FIRE SAFETY ASSESSMENT

Maitland Regional Art Gallery

Report Number: 210705-11

Revision: B – Issued for comment

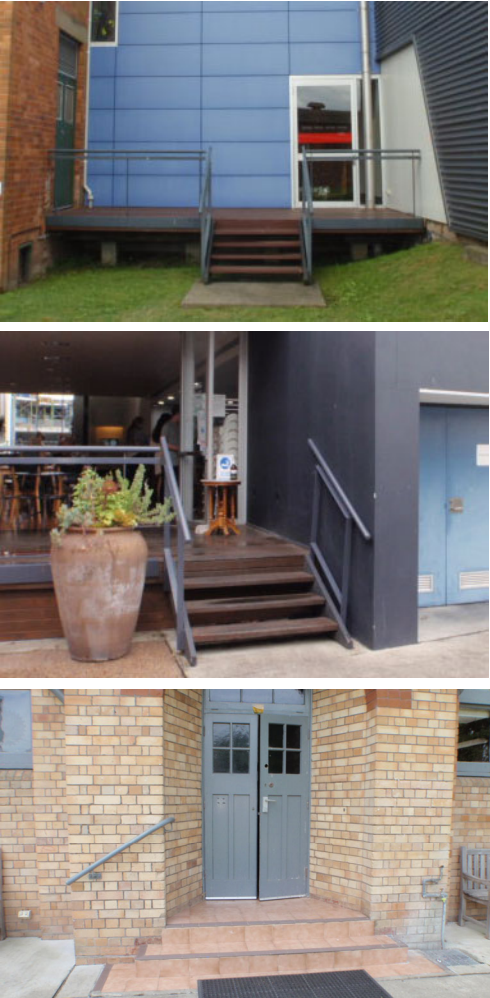
1.5	<p>Fire indicator panel - Maintenance records in the AS1851-2012 logbook reflect regular inspection testing and maintenance to AS1851. Monthly and yearly routines are recorded with the last yearly routine in July 2021.</p> <p>Two faults were identified with beam detectors on the ground floor that failed to operate. There is no record of whether the faults have been repaired.</p>	<p>Verify the correct testing procedure was adopted for the beam detectors.</p> <p>Investigate, retest and repair accordingly.</p>	Performance	0.5 - 2K

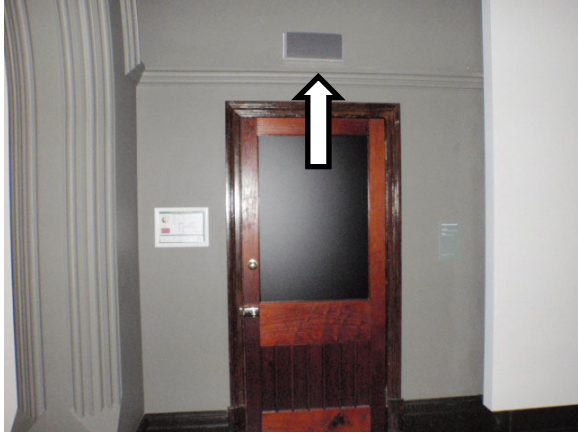
Measure	Ref	Issues / Information	Recommendations	Key	\$ Estimate
Emergency lights (cont'd)	2.6	<p>External stairs connecting the ground floor exit doors to ground level have no emergency lighting. The stairs are considered as required stairs and must be provided direct illumination from an emergency light.</p> 	<p>Install a weatherproof emergency light to provide direct illumination of not less than 1 lux to the external stairs in accordance with AS2293.1.</p> <p>The emergency light is to be supplied from the DB controlling the normal lighting in the area and interfaced to both the normal lighting serving the area and the test timer unit.</p>	Performance	2.5K

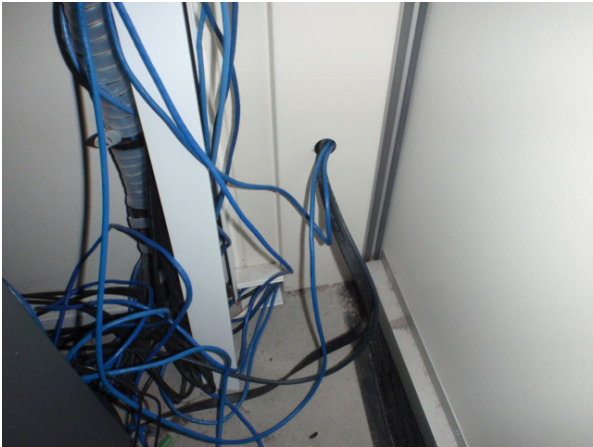
5.2	<p>The stair at the eastern end of building A has fire rated door frames with compliance tags that have been painted over. The doors have been replaced with non fire rated doors.</p> <p>This stair was no longer required to be fire rated or be considered as an exit when the 2009 extensions were carried out as additional exits and paths of travel were provided. The doors in question are not considered fire rated and do not need to be maintained as such.</p>	Na	Information	-

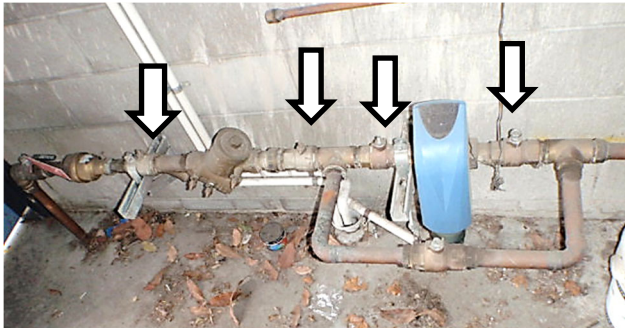
5.4	<p>1st floor air conditioning pump room – Fire rated door assemblies are installed at the entry to the air conditioning pump and water heater room and the door connecting to the main electrical switch room. BCA part C2.12 requires rooms containing <u>boilers</u> to be separated by 2 hour fire resisting construction. The door assembly rating is limited to that of the frame which is -/60/30, so falls short of the requirements irrespective of the -/120/30 rating of the door.</p> <p>The BCA does not require the hot water / pump room to be fire separated unless it contains a <u>boiler</u> as per BCA part C2.12. There was no definition of a boiler in BCA2008. Current BCA includes a definition of a boiler with the following exclusion;</p> <p><i>'excludes a fully flooded or pressurised system where water or other liquid is heated to a temperature lower than the normal atmospheric boiling point of the liquid'.</i></p> <p>The unit may not meet the criteria of a boiler as defined in current BCA based on this exclusion. It was indicating a temperature of 75°C at the time of our inspection.</p> <p>The fire rated construction may be due to misinterpretation of the unit as a boiler, or it may have been as a voluntary measure to protect assets in the building. Further investigation is required to verify the hot water unit does not meet the definition of a boiler.</p>	<p>Investigate to verify whether the hot water unit labelled 'Boiler' meets the definition of a boiler as defined in the current BCA in the definition section.</p> <p>Investigate the approval files and design documentation to verify whether some form of concession was applied. Obtain an opinion from an accredited principle certifying authority on the inclusion on the fire safety schedule. Upgrade the construction and fire door assemblies to comply with AS1905.1 as per the principle certifying authority advice.</p>	Non-conformance	1-5K

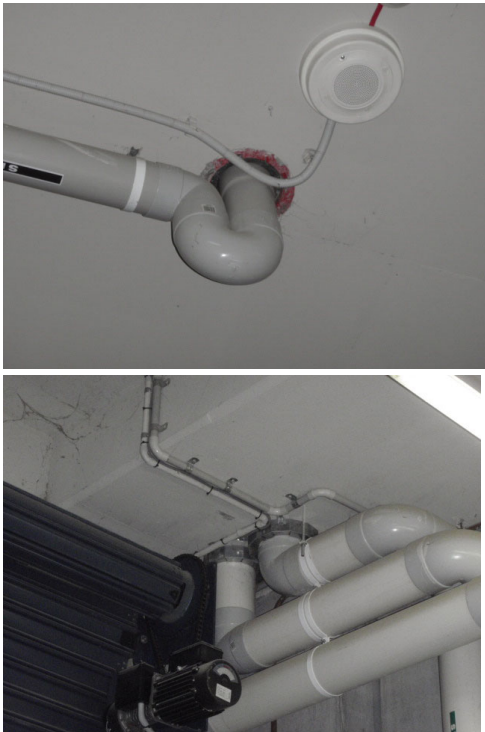
8.3	<p>Ground floor distribution board enclosure behind reception – The walls are constructed of fire rated plasterboard with numerous penetrations sealed however a number have not been sealed.</p> <p>There are no provisions in BCA requiring such an enclosure to be fire rated and include fire seals. We suspect the construction has been employed mistakenly by the builder to meet the requirement for a non-combustible enclosure for the switch board as per BCA part D2.7. We have omitted the fire seals for this area.</p>	<p>To prevent future confusion during assessments, place a sign / label on the walls advising the enclosure is not required to comply as a fire rated construction and only requires non-combustible construction with smoke seals. The signs should be placed on each wall inside the enclosure.</p>	Non-conformance	0.2K
